BLOOMINGTON HISTORIC PRESERVATION COMMISSION

Thursday February 13, 2014

AGENDA

Keith Romaine / 907 South Madison Street
 Site Plan 1/16" SCALE

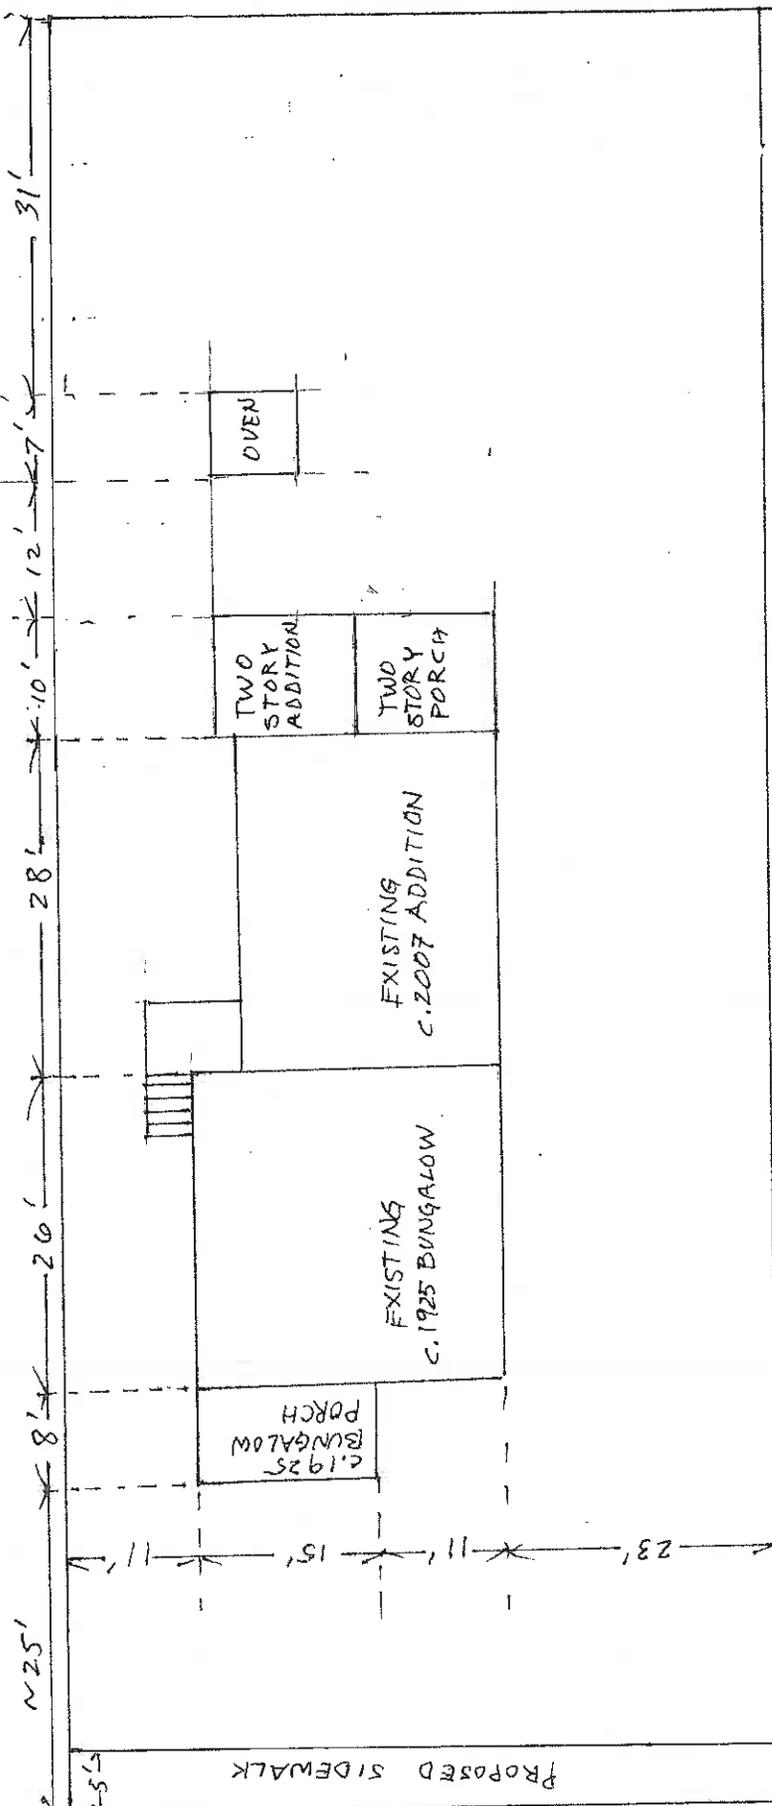
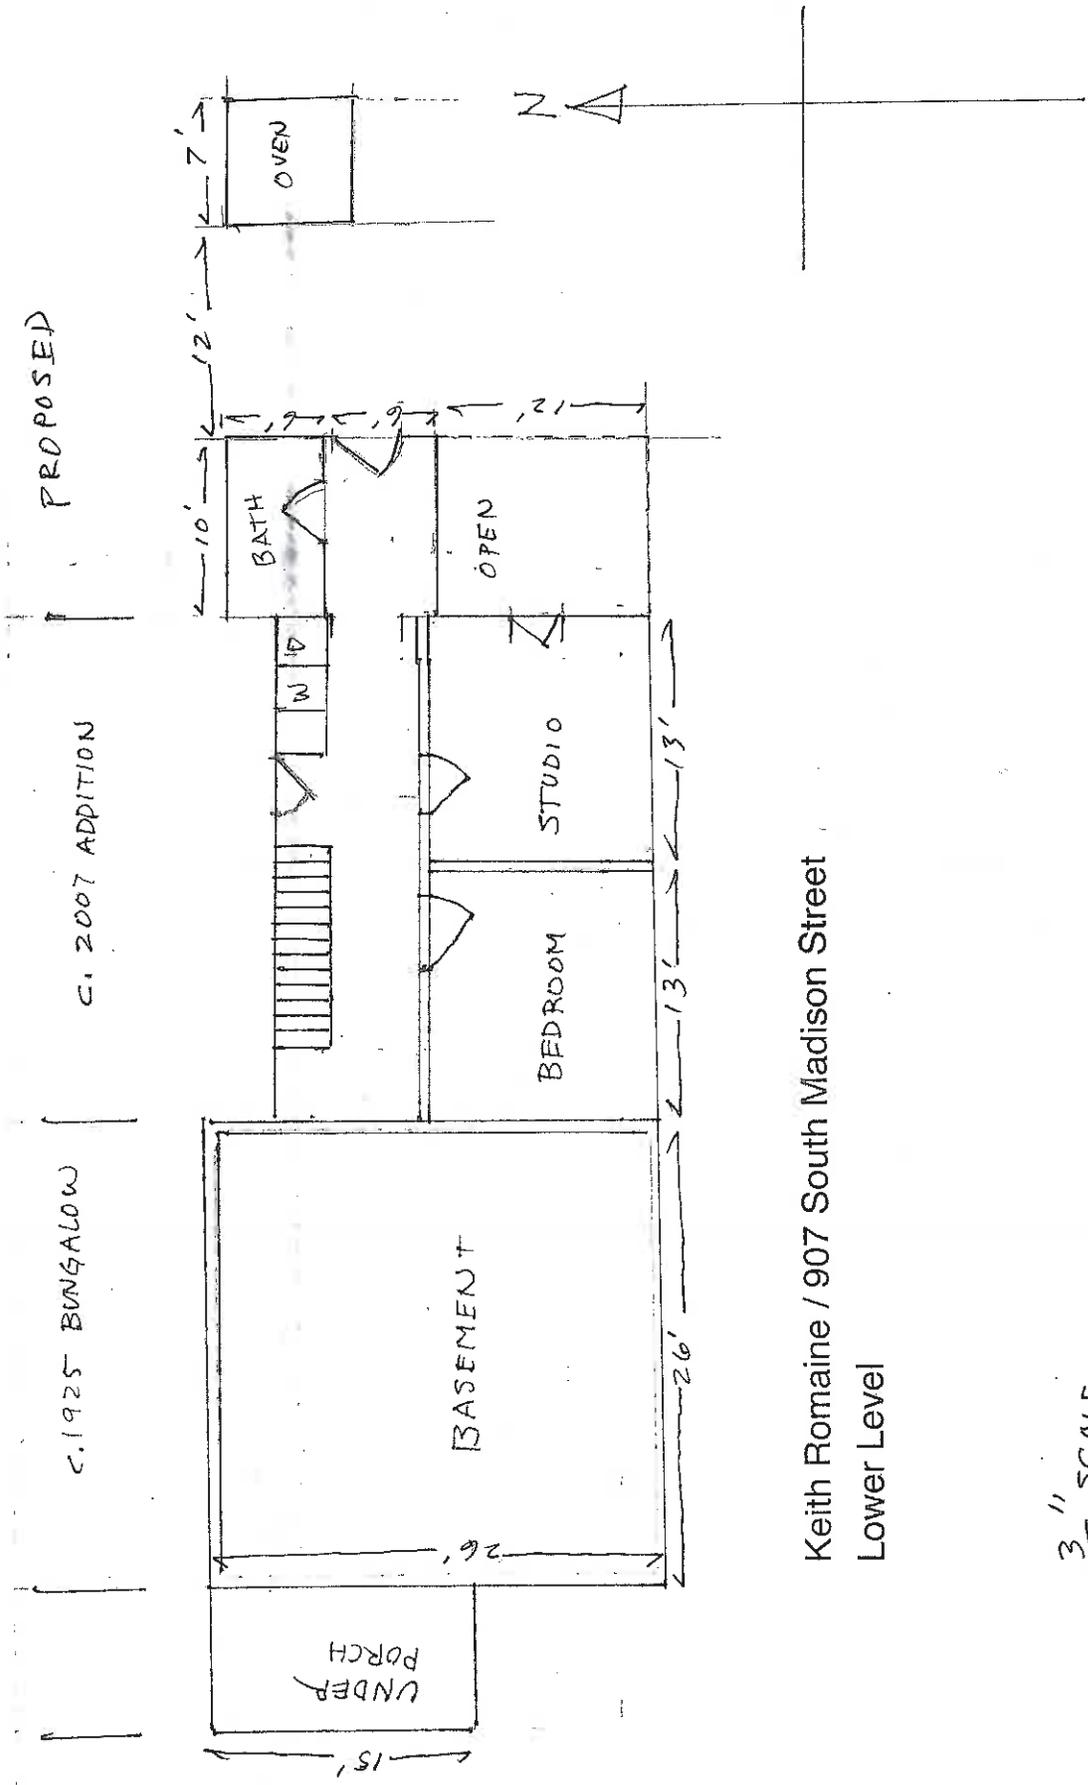
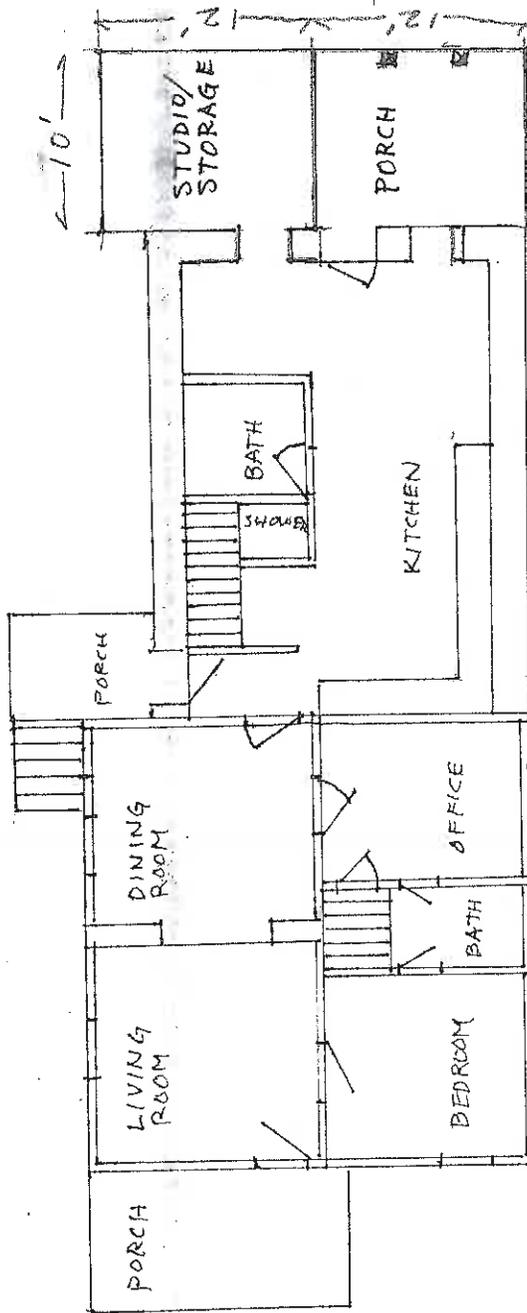
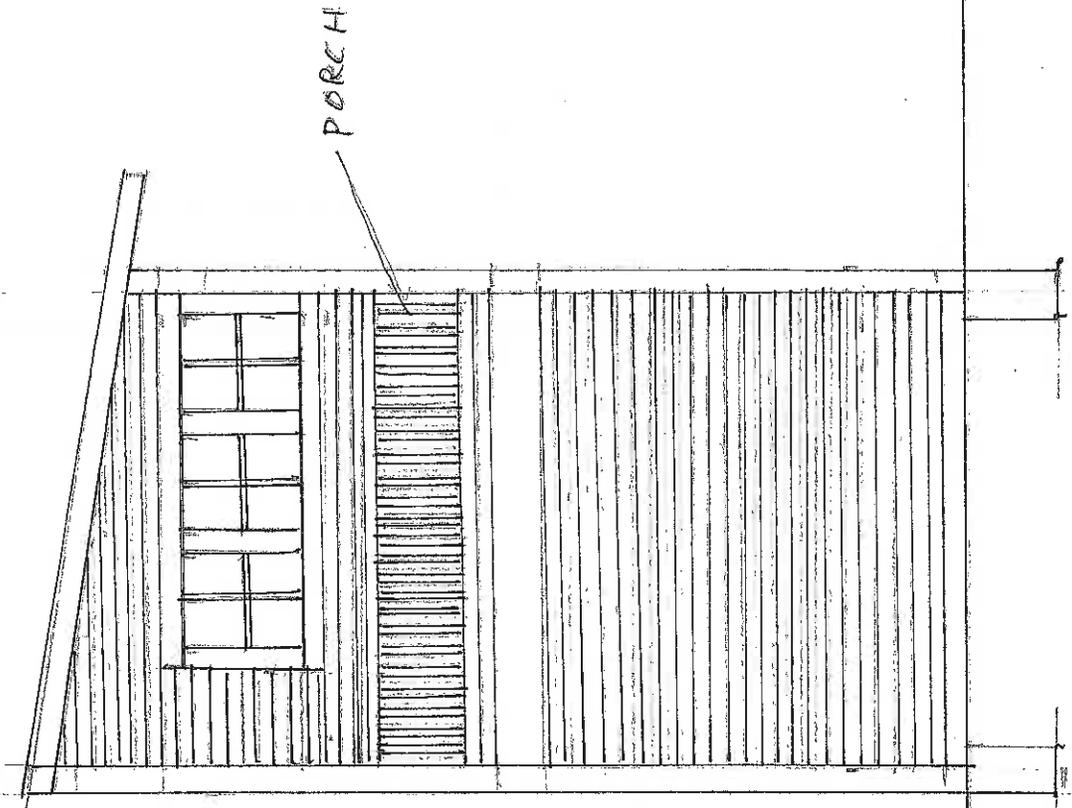
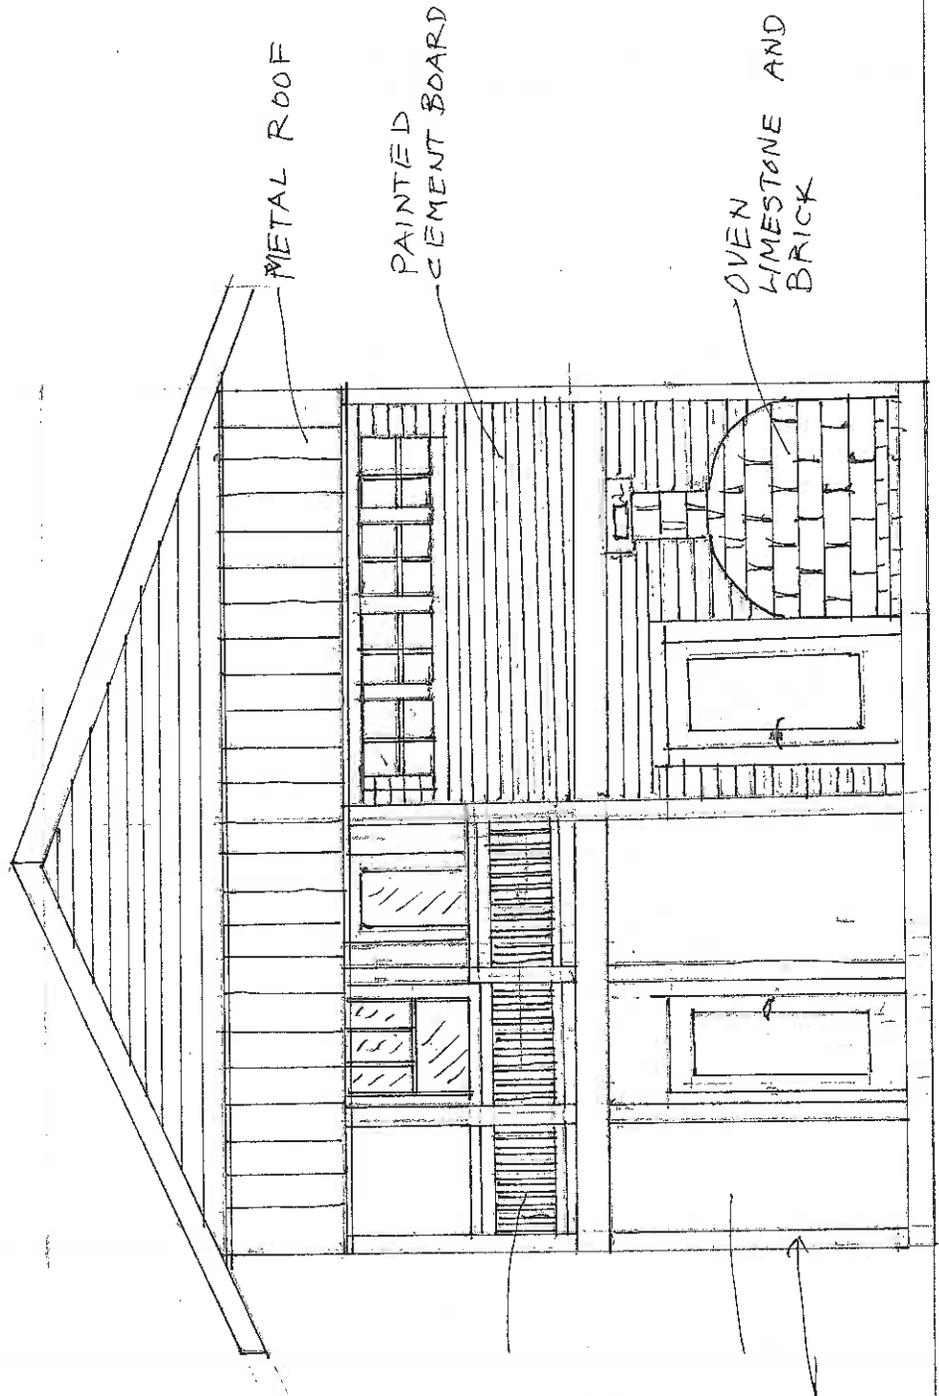
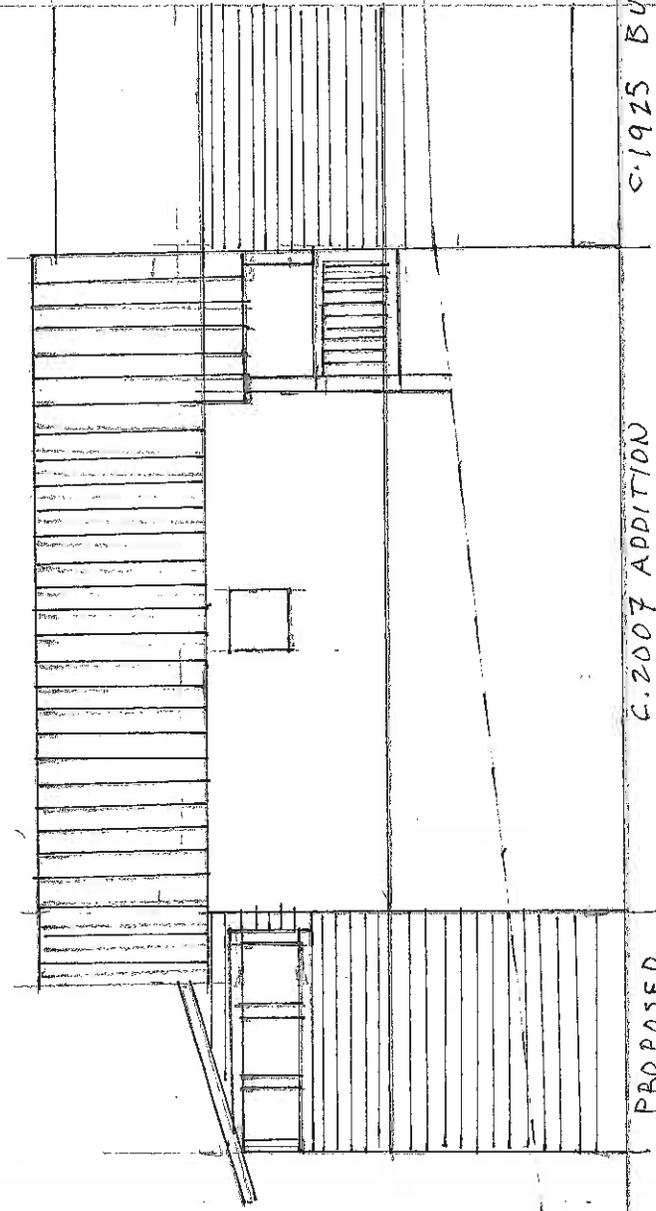
Behind the house, the owner plans to build a brick and limestone baking oven about 7'x7' in dimension. The design is included.

Photographs clearly show the dramatic slope of the lot to the rear and that it easily accommodates a two story addition. The height of the new proposal will be lower than the main house and 2007 addition. The shed roof will cut beneath the gabled 2007 addition.

The proposed addition is placed at a setback equal to or slightly less than the original house. The lot accommodates the added length, since at 146" it is about 25' longer than the standard.

The McDoel Subcommittee has reviewed this plan and recommends approval. The plans have already received a BZA variance to conduct a home occupation and to offer direct sales. This activity was also supported by the neighborhood.
